STATE OF TENNESSEE
DEPARTMENT OF ENVIRONMENT AND CONSERVATION
DIVISION OF MINERAL AND GEOLOGIC RESOURCES
3711 MIDDLEBROOK PIKE
KNOXVILLE, TENNESSEE 37921-6538
PHONE (865) 594-6035 STATEWIDE 1-888-891-8332 FAX (865) 594-6105

Mining Facility Inspection Report

NPDES permit number: TN0063606

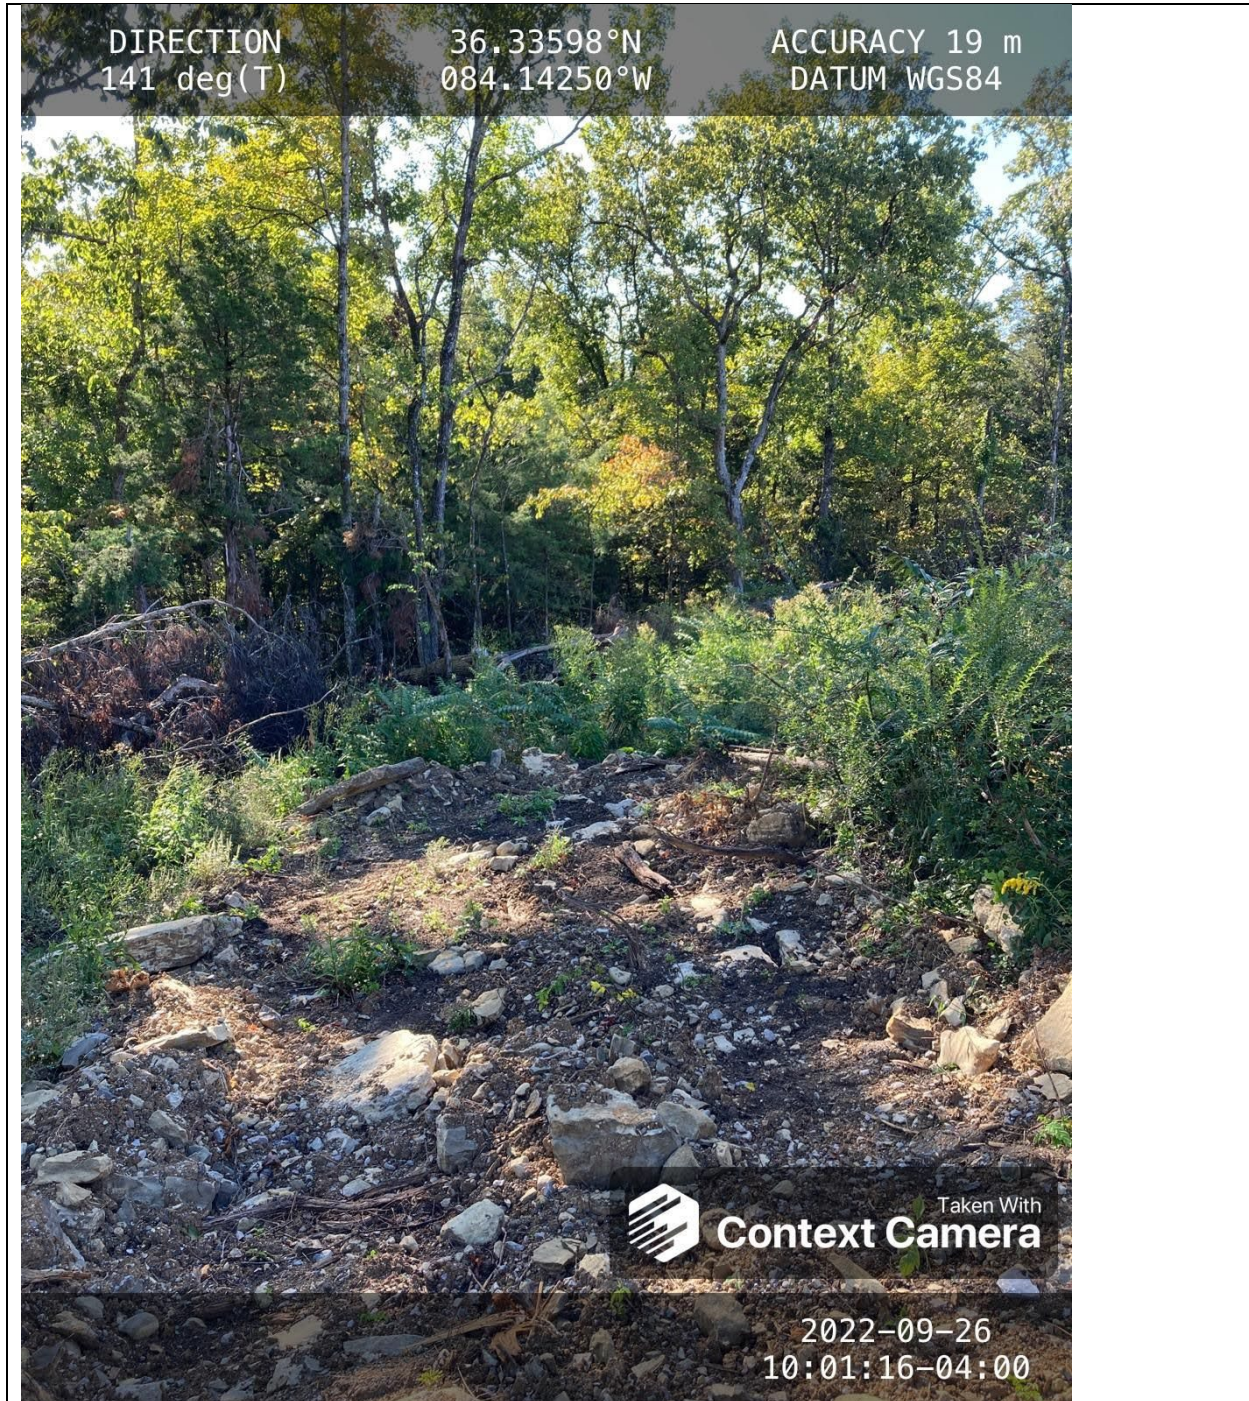
Taken With Context Camera 2022-09-26 09:54:01-04:00		
36.33658 -84.14432 17.2227465785748 2022/09/26 09:54:01		
Item 1:View of the area that has been clear cut. The area slopes away from the pit and thus needs stabilization measures such as seed/straw, mulch,rock, etc. Brush berms are not approved BMPs. Temporary BMPs should be installed such as silt fences until more permanent BMPs are installed.

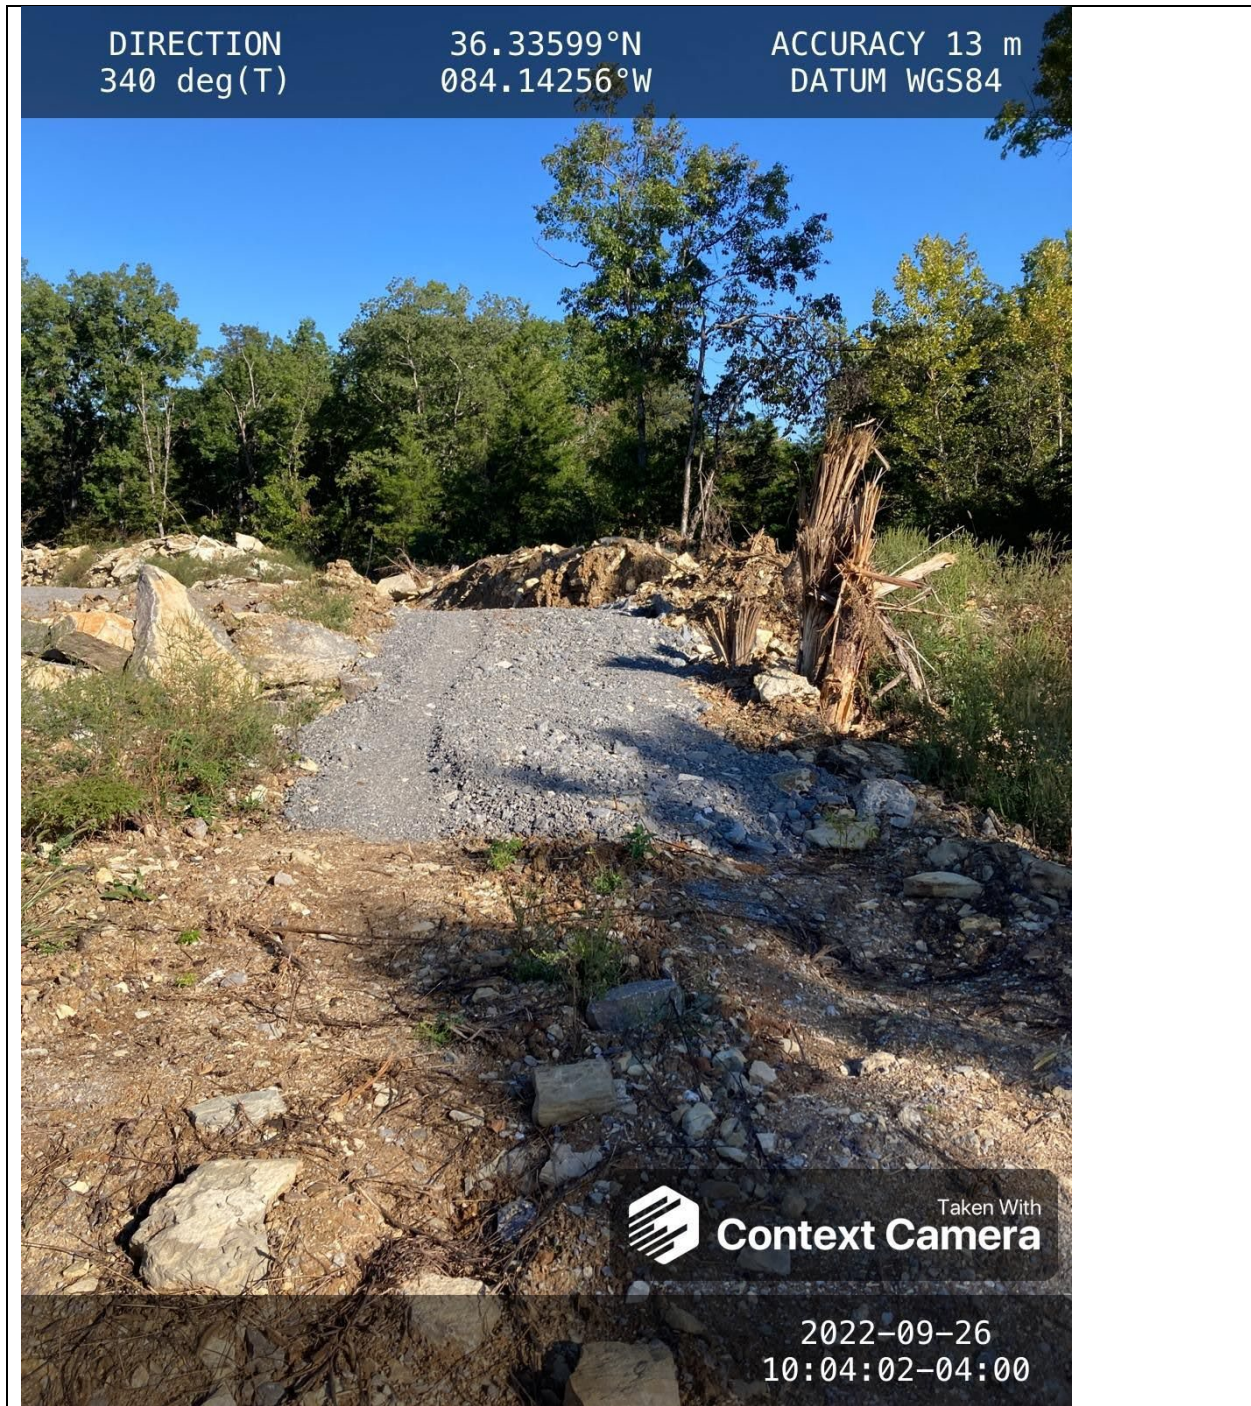
Item 3: Another view of the back slope area that needs additional stabilization measures.

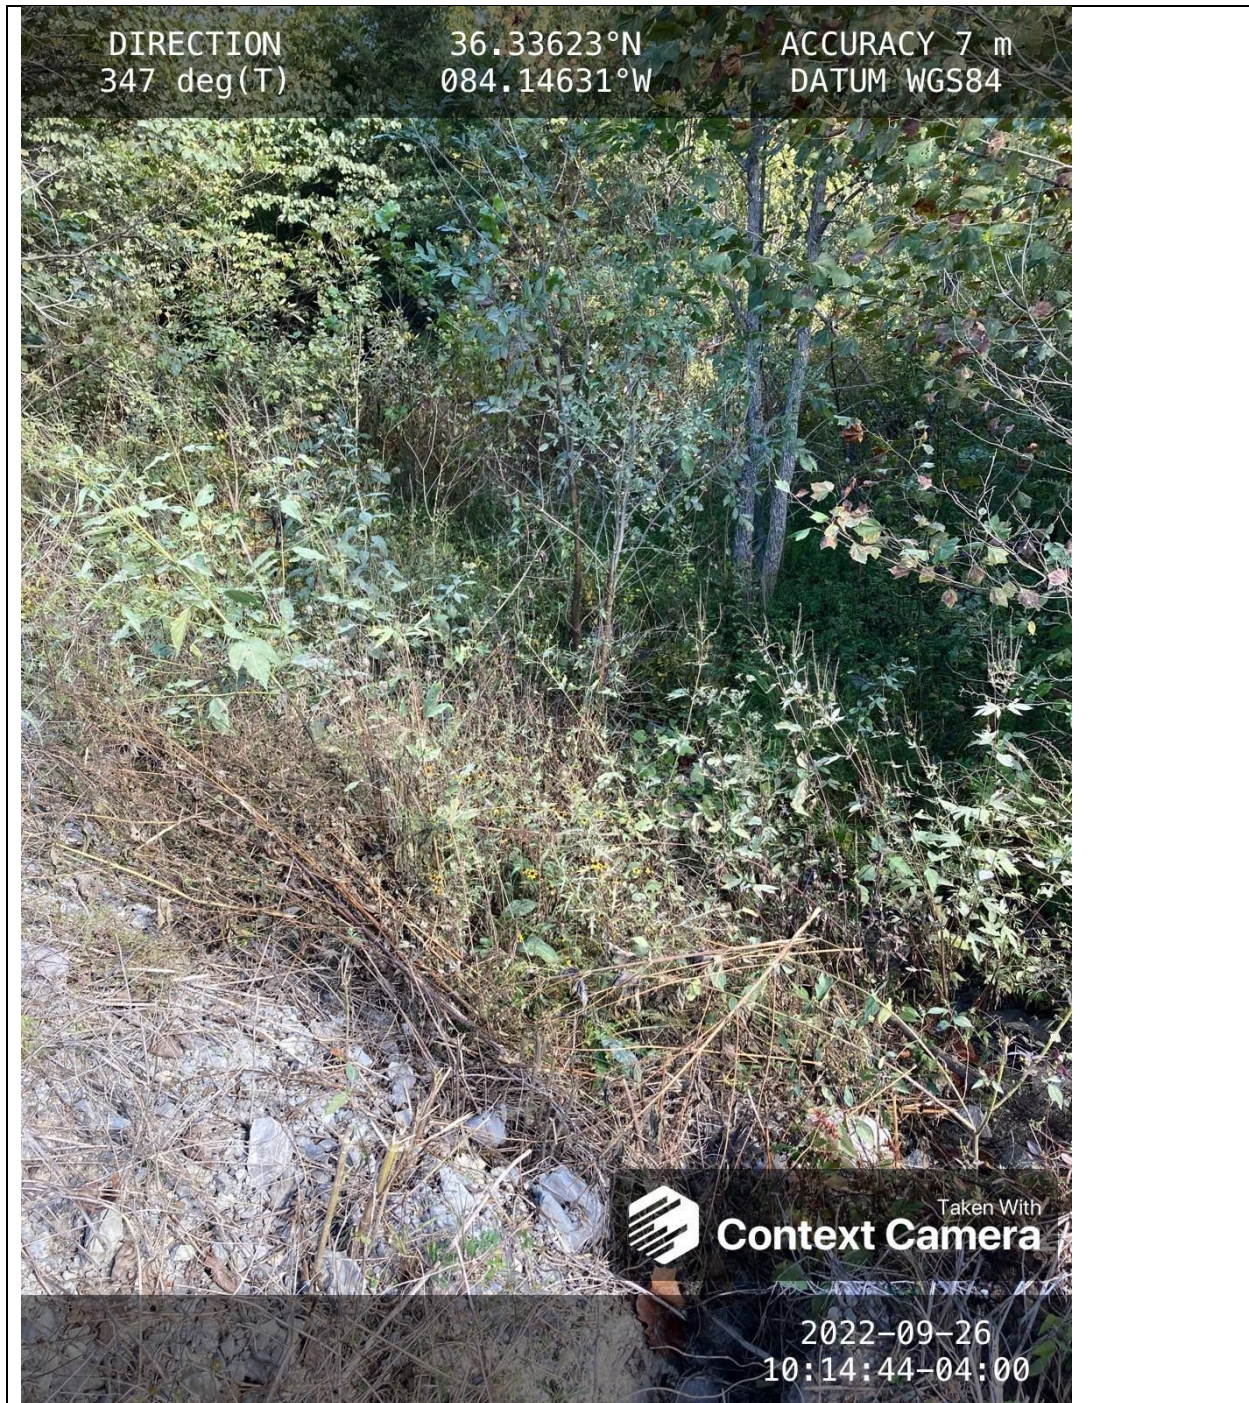
Taken With Context Camera	
		2022-09-26 10:05:21-04:00	
36.33548 -84.14263 8.395221260514447 2022/09/26 10:05:21			
Item 5: Back haul road area from Picture 4 that needs additional stabilization methods.

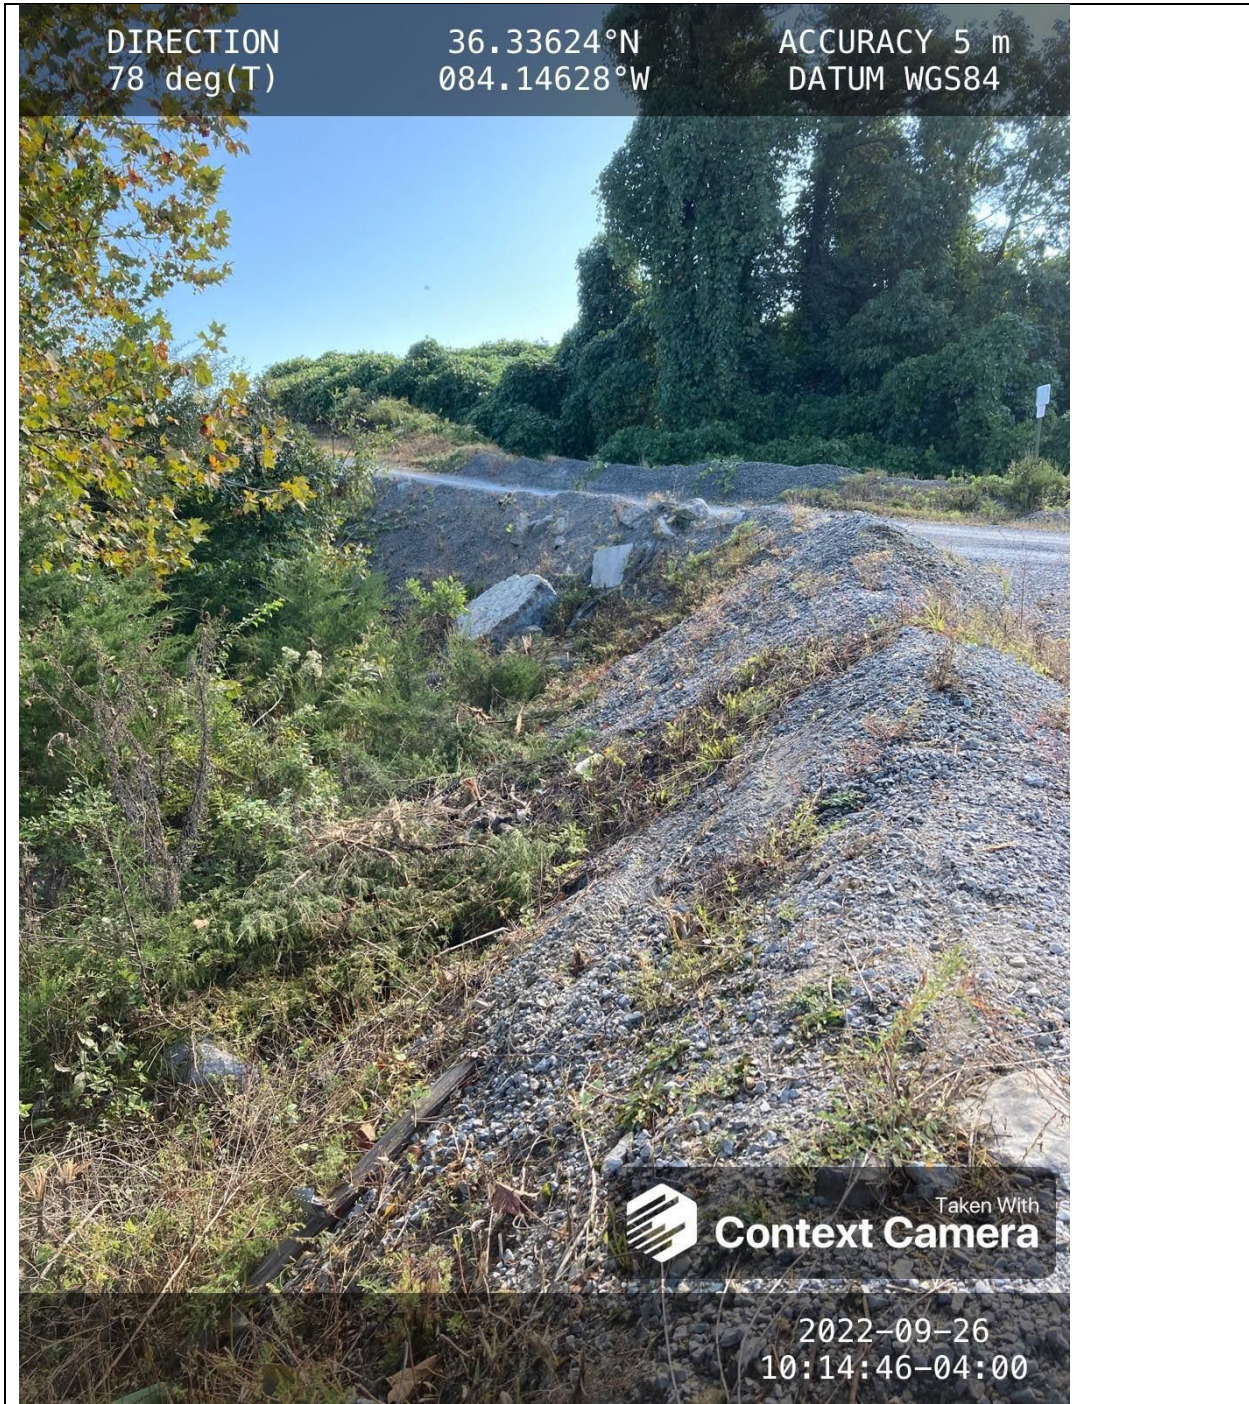
Item 6: Pond 002 area according to the map. Water from the pit gets pumped to it, and the pumps were not running at the time of inspection. This pond should be cleared out and more clearly defined on site with the defined outfall point to ensure adequate monitoring can be conducted.

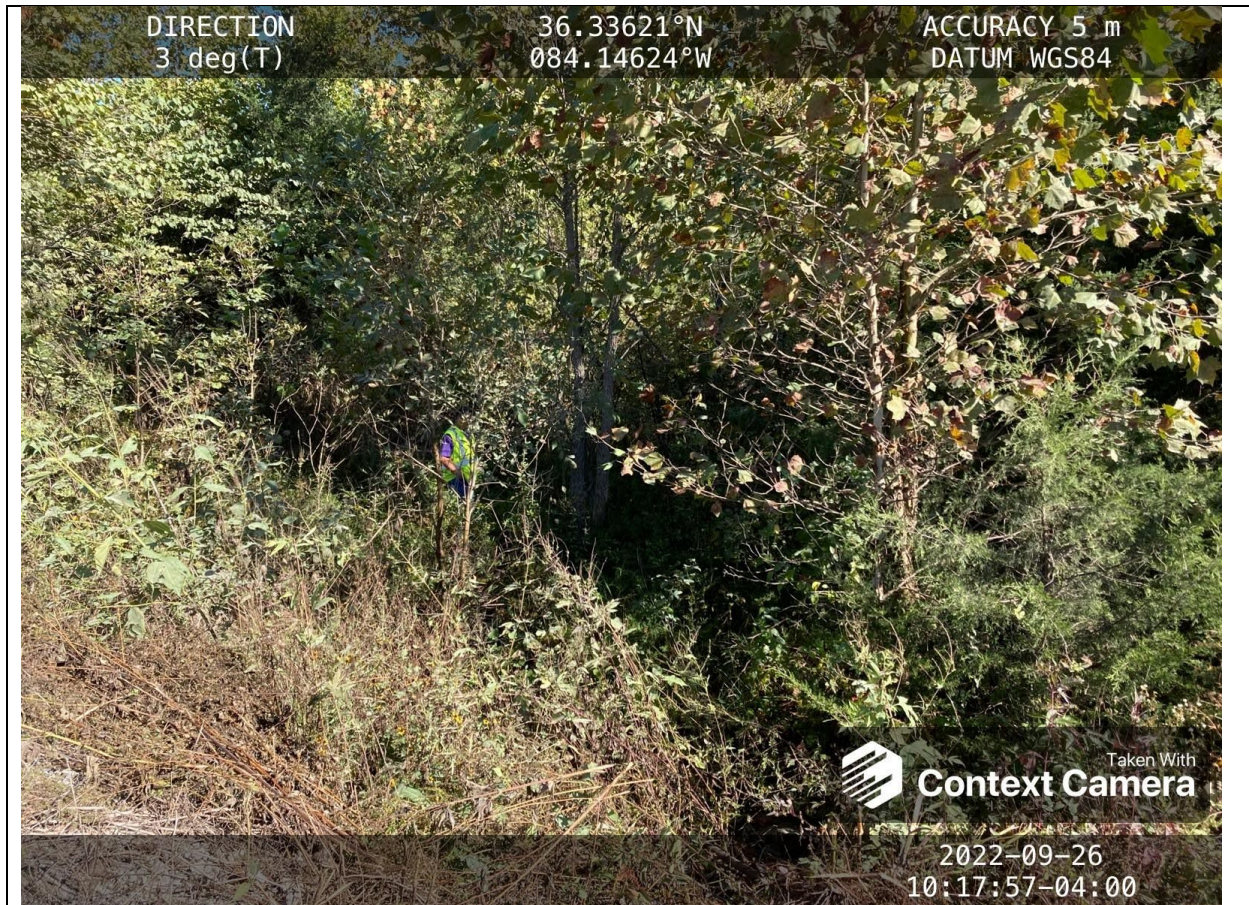
Item 7: Culvert area that gets water from the quarry pit when water is pumped out.

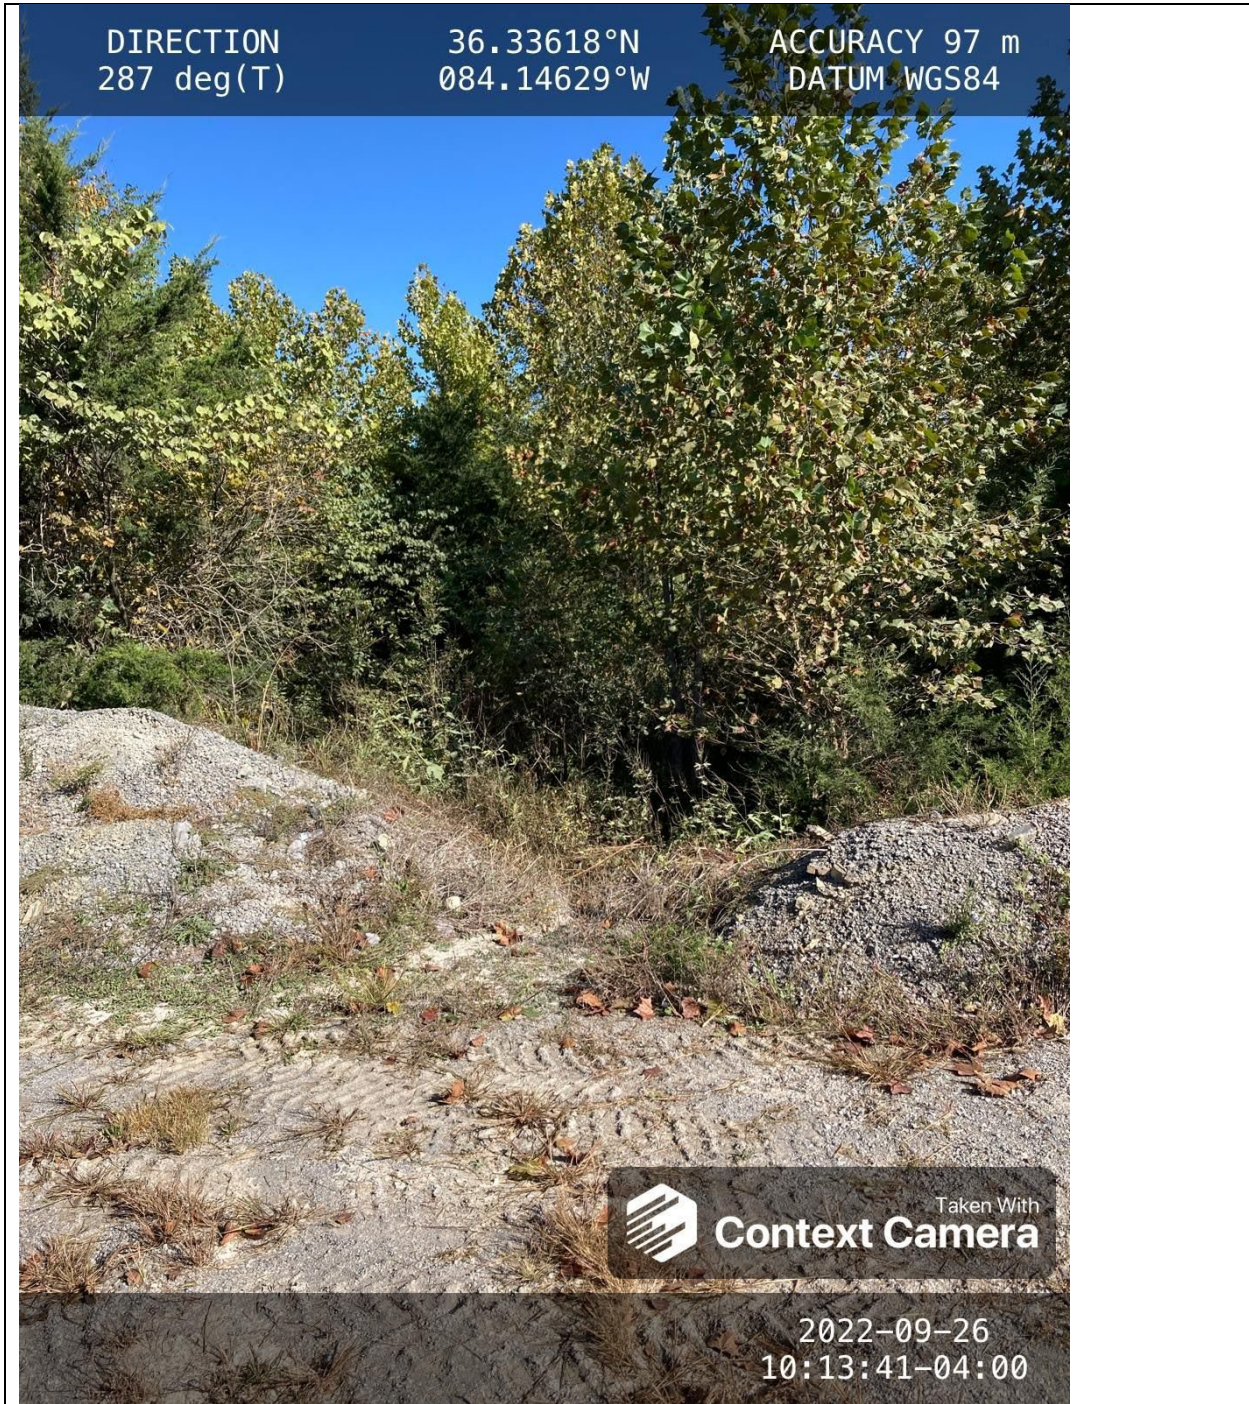
Item 8: Pond 001 area that should be cleared out and more clearly defined on site with the defined outfall point to ensure adequate monitoring can be conducted.
